N6743B-01

S E R V I C E N O T E

N6743B 100W DC Power Module

Location of C36 and C37

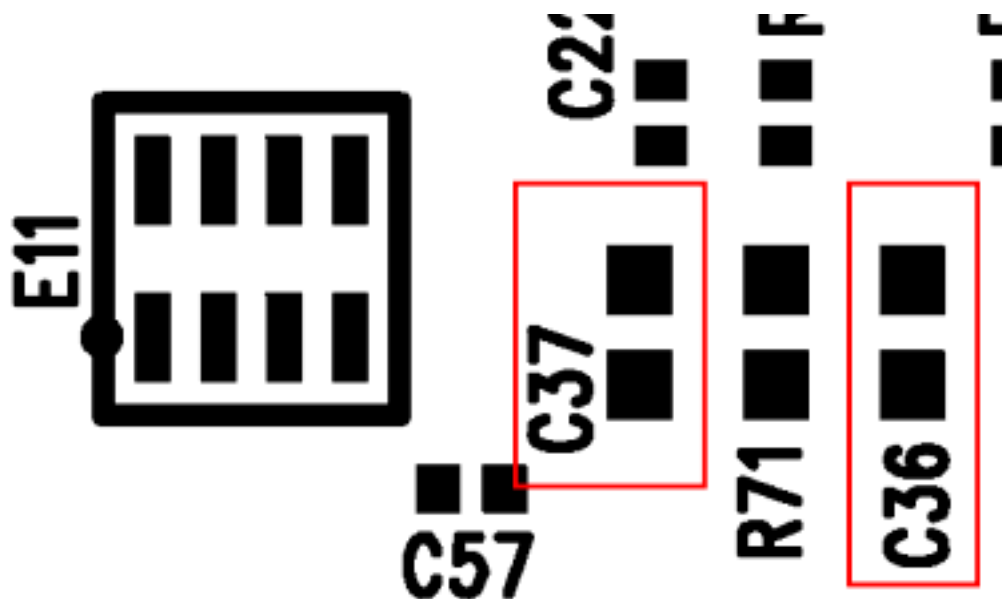
Due to some noise filtering issues, the current measurement accuracy will be out of specification by a fixed offset when there is a voltage being sourced at the output terminals. If the output is shorted, the current measurement accuracy will be within specifications. Please note that the performance verification test will not catch this.

If this measurement is out of specification, replace capacitors C36 and C37 on the DPM assembly (this is the assembly that is vertically mounted in the unit that looks similar to a PC memory module) with part number 0160-7809. After the capacitors are changed, the unit will require re-calibration. After the capacitors are replaced, check the make sure that the unit is in specification by applying 75% of the full voltage range while attached to a load drawing 50 mA to 70 mA. If the current measurement is within the specification, then the unit has been repaired.
